ADDENDUM NO. 1

FOR: RUNNING TRACK REPLACEMENT
JOB NO. 0123243.01-020/320

OWNER: LINCOLN PUBLIC SCHOOLS (LINCOLN SOUTHEAST HIGH SCHOOL)

DATE: MARCH 1, 2024

STORM DRAINAGE PLAN

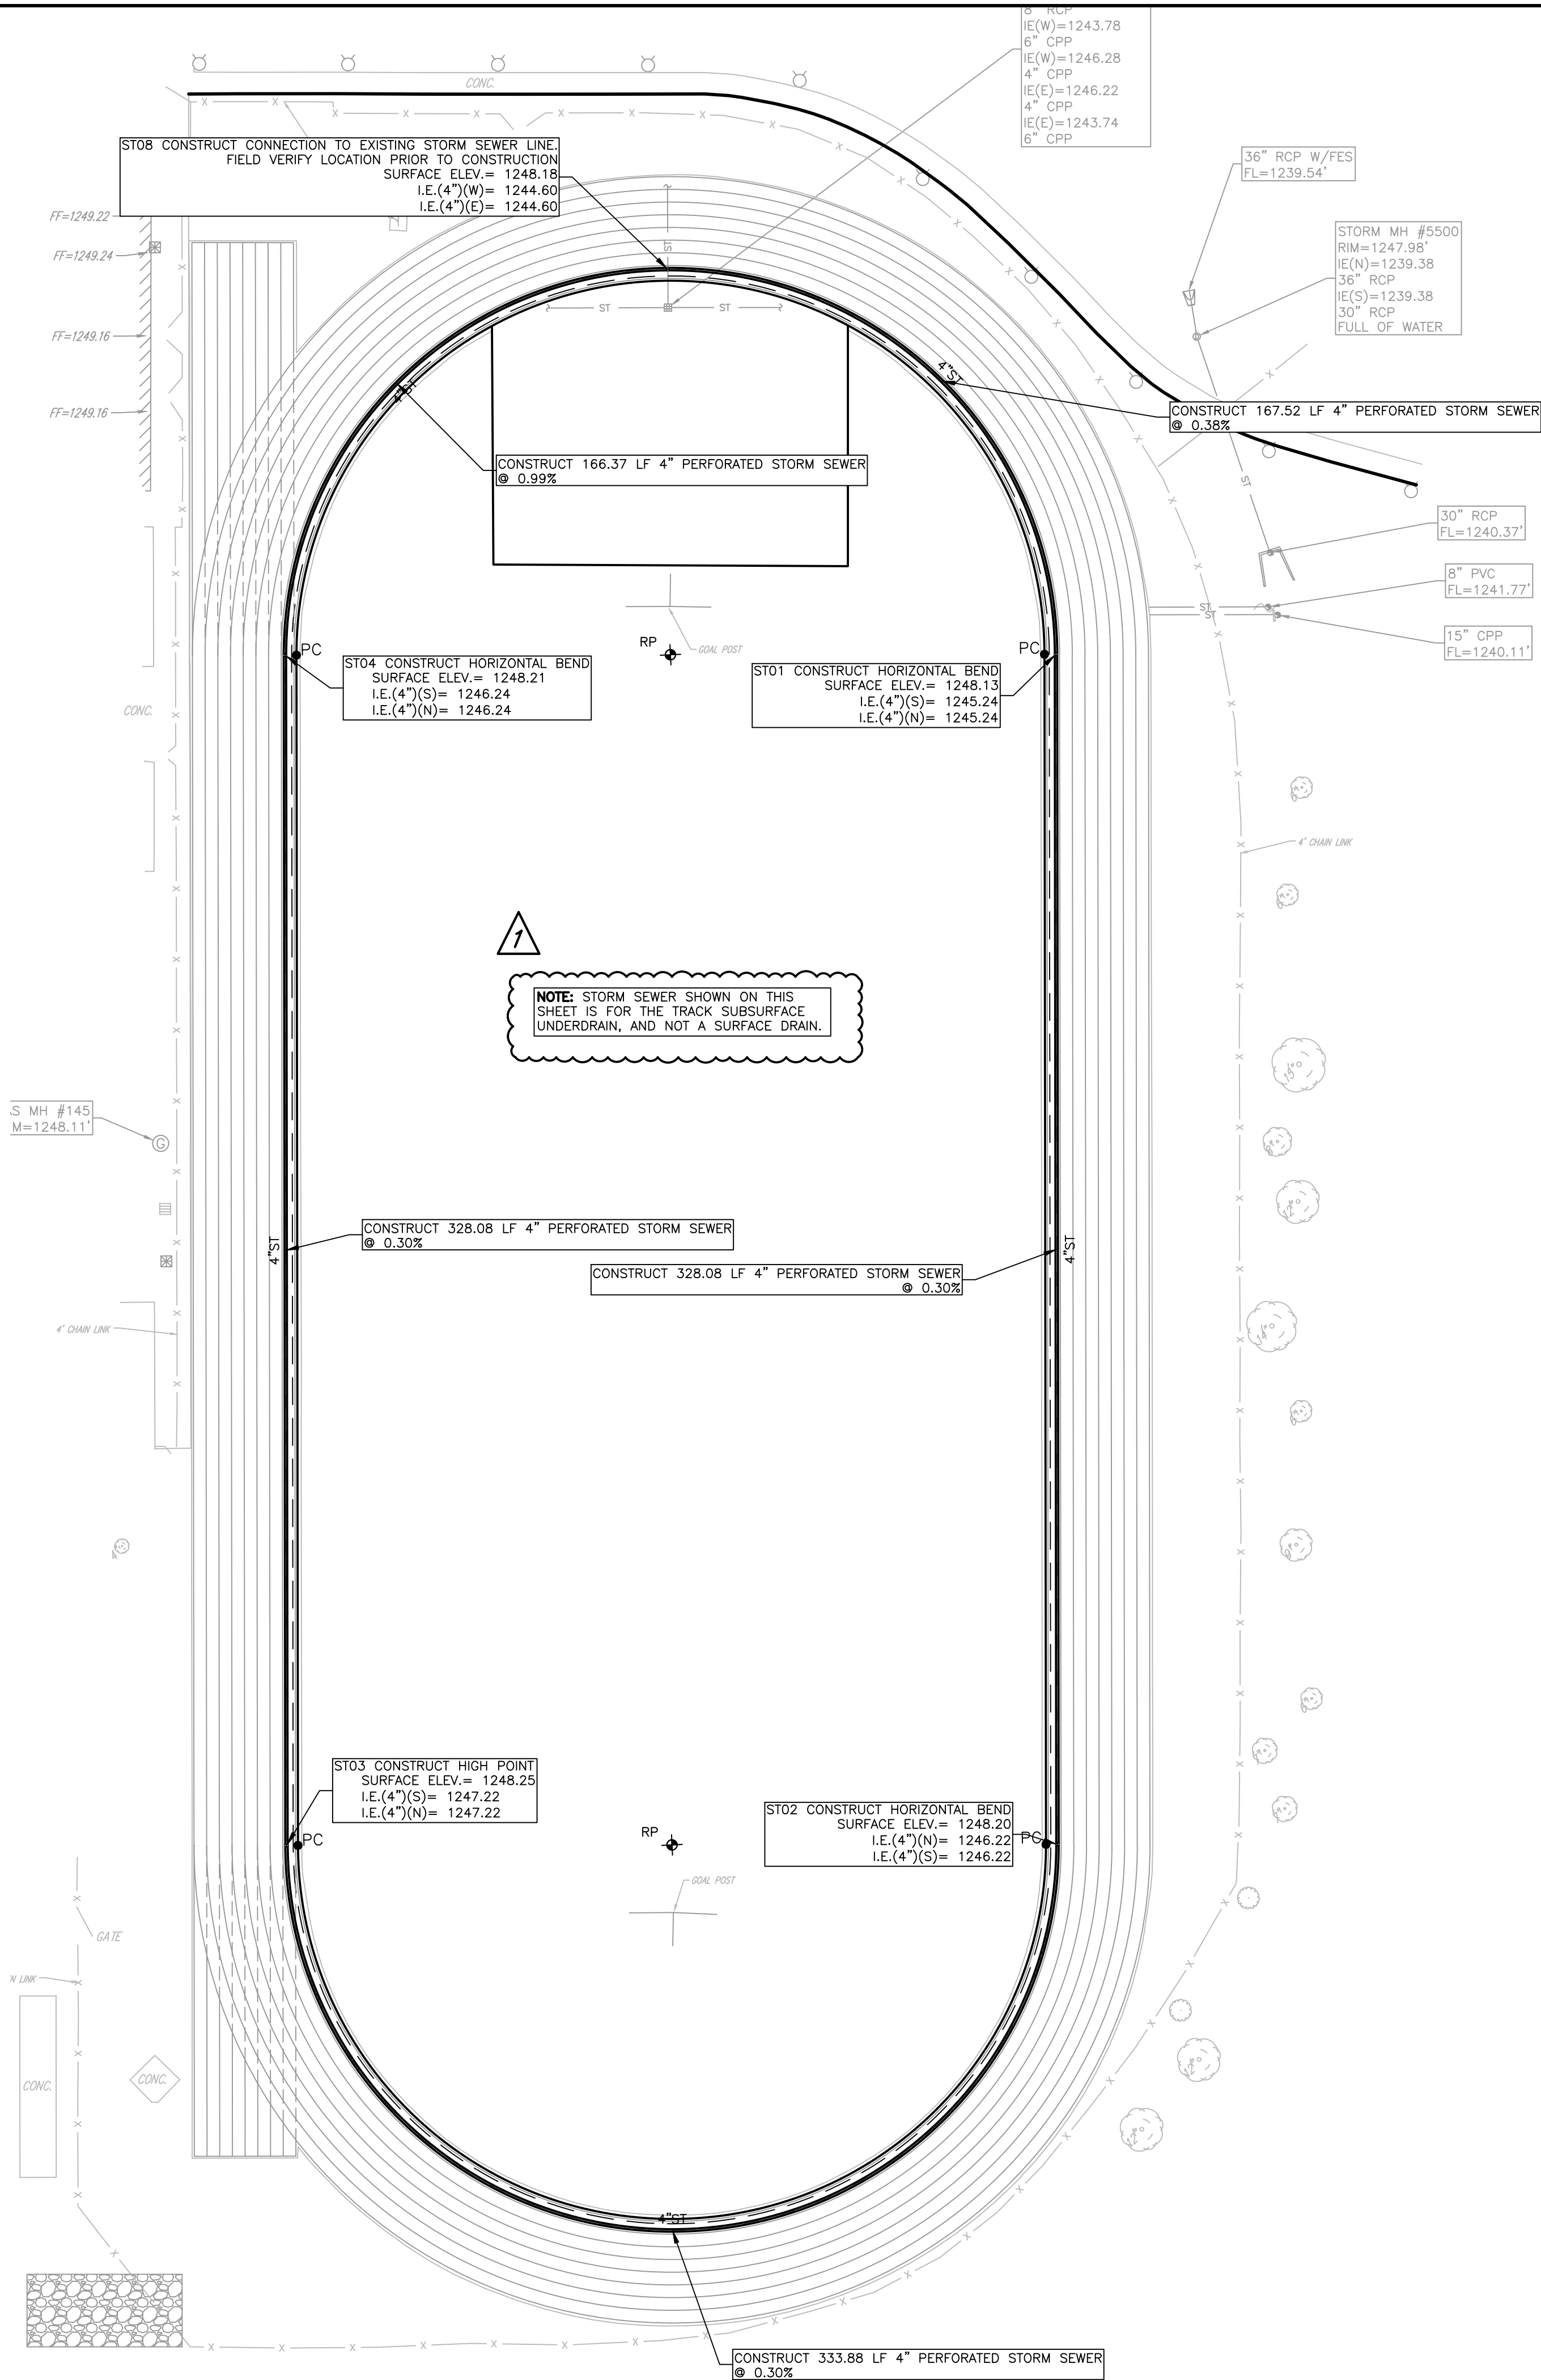
1. SHEET 1: Notating revision 1 and date of revised sheets.
2. SHEET 6: Notating revision 1, revised note within football field.
3. SHEET 7: Notating revision 1, revised note 1. In ACC paving notes.
4. SHEET 8: Notating revision 1, revised detail track asphalt section bid and transverse section through football field.

- 6" DEPTH CRUSHED LIMESTONE SHALL BE PLACED UNDER THE ASPHALT BASE OF THE TRACK AND THE CONCRETE BASE OF THE D AREAS. SEE DETAIL SHEET 8.
- 4" PERFORATED DRAIN COLLECTOR PIPE SHALL BE CONSTRUCTED AROUND THE INSIDE PERIMETER OF THE TRACK AT A 0.30% MINIMUM SLOPE. OUTLET SHALL TAP INTO THE EXISTING STORM DRAIN SYSTEM.
